Squeaks & Rattles – Noise from Traction Control Actuator – Install Isolating Pads

MODEL 1995 MY
Sedan Range
VIN 720001 - 734054

ILLUSTRATION 1

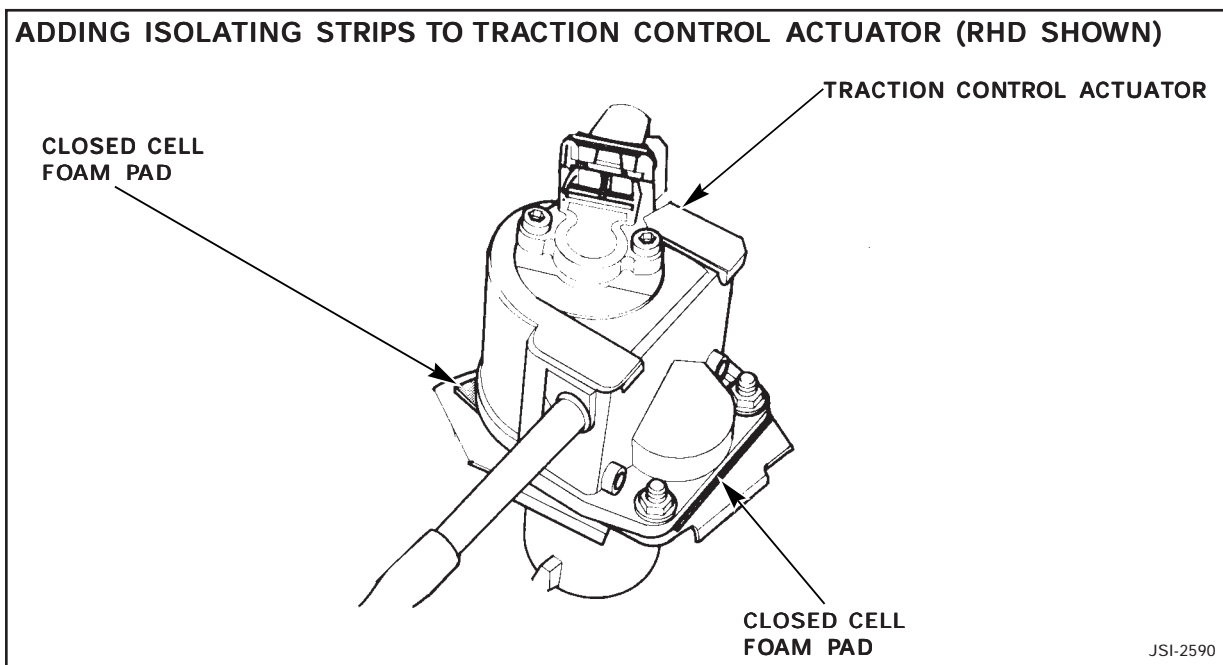
Some Sedan Range vehicles, within the above VIN range, equipped with traction control may experience a noise that the customer reports as coming from the right side of the fascia. The source of the noise may actually be in the engine compartment and be caused by vibration of the traction control actuator on its mounting.

Starting with VIN 734055, foam isolating pads are installed between the traction control actuator and its bracket.

1. Loosen the two screws that secure the traction control actuator on its mounting bracket.
2. Cut two 25/64 in. (10 mm.) wide strips from a closed cell foam pad.
3. Raise the actuator and insert the two strips between the mounting bracket and the actuator as shown in Illustration 1.

4. Retighten the two mounting screws.
